Replacement of SC 41 Bridge over Wando River Charleston and Berkeley Counties File 8.158B & 10.032100 Federal Aid Project No. BR88 (079)

NOTICE TO PROPOSERS

NOTICE TO PROPOSERS - Enclosed is Addendum #1 to the Request for Proposals (RFP) package for the Replacement of the SC 41 Bridge over the Wando River. The information provided in this notice and the addendum shall be made part of the contract documents.

Addendum #1 is being issued in order to provide clarification and additional information for the project.

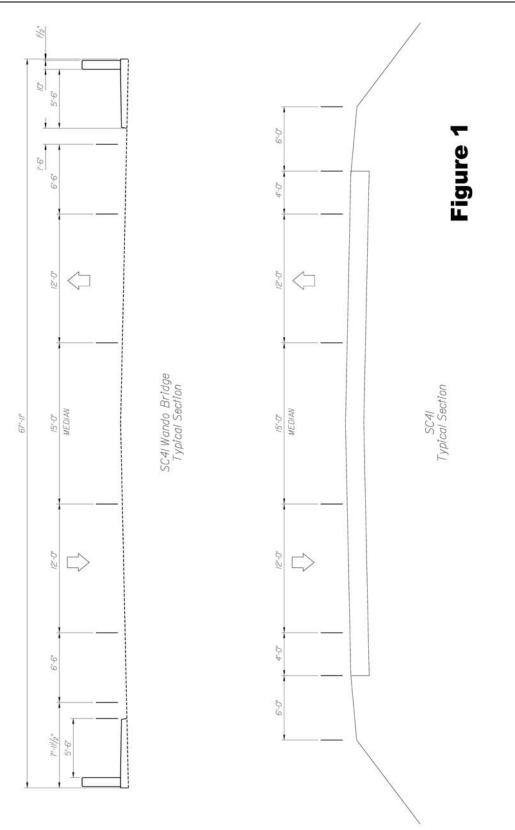
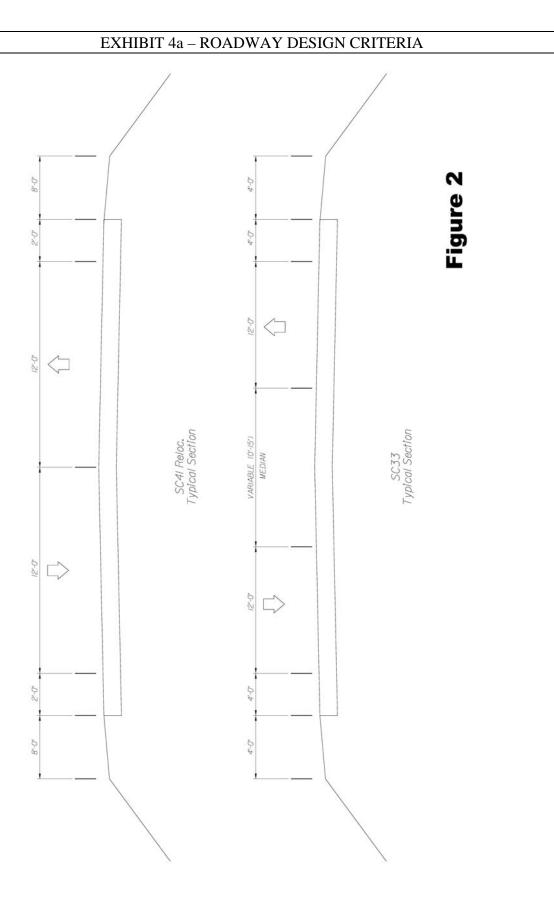
Clarification regarding Access Road and SC 41 Relocated intersection design requirements and typical sections.

The typical sections shown in Figures 1 and 2 should be used for the project. The full width median on SC 41 shall, at a minimum, begin south of the Access Road intersection in order to develop the left turn lane into the Access Road. at the south end bridge approach slab and continue through the relocated intersection of SC 41 and S-33 Clements Ferry Road tapering back down to a 2 lane section on S-33 beyond the auxiliary lanes.
